UNITED STATES PATENT AND TRADEMARK OFFICE

10/588,936

Office Action Summary	Application No. 10/588,936	Applicant(s) TABATA ET AL.	
	Examiner Lucas Stelling	Art Unit 1797

DETAILED ACTION

FIG.12

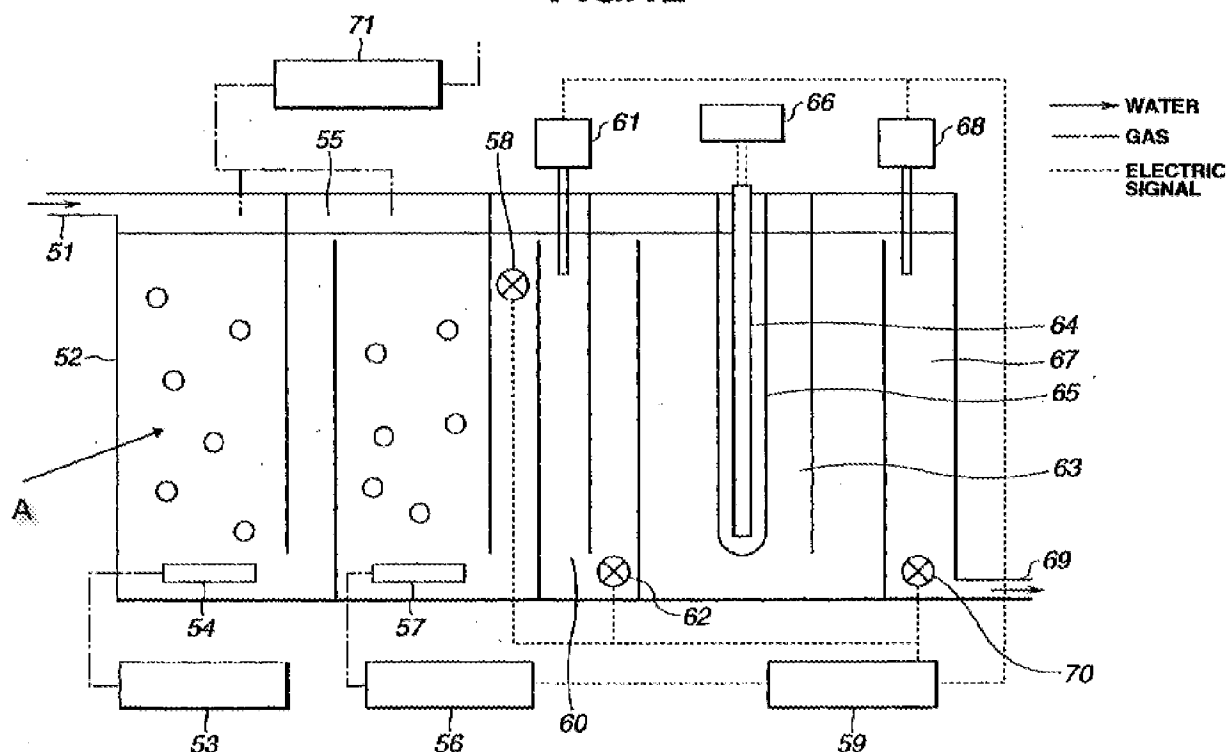
a treatment bath for treating the water (**See Noguchi Fig. 12, and edited Fig. 12 below, 'A' represents the treatment bath into which ozone is provided through 54 see also [0046]**);

an oxidizing reagent adding unit for adding an oxidizing reagent in the water treatment bath (**54 and see [0046]**);

an ultraviolet treatment unit for irradiating an ultraviolet ray (**64 and see [0046]**);
and

an acid treatment bath (**60**) having an acid adding unit for adding acid (**61**), provided on a downstream side of the wastewater treatment bath and on an upstream side of the ultraviolet treatment unit (**See Noguchi Fig. 12 and see edited Fig. 12 below**).

The examiner acknowledges that applicant has further claimed limitations directed to the pH of the water in the acid treatment bath. These limitations are directed to the material operated on by the apparatus and functional limitations of the apparatus and do not serve to further define the apparatus in terms of its structure. See MPEP 2114 and 2115. The apparatus of Noguchi is fully capable of performing the functions recited in the claims. Nevertheless, Noguchi contemplates a pH of not higher than 4 for the photocatalytic reaction in other embodiments (**See Noguchi [0036]**).
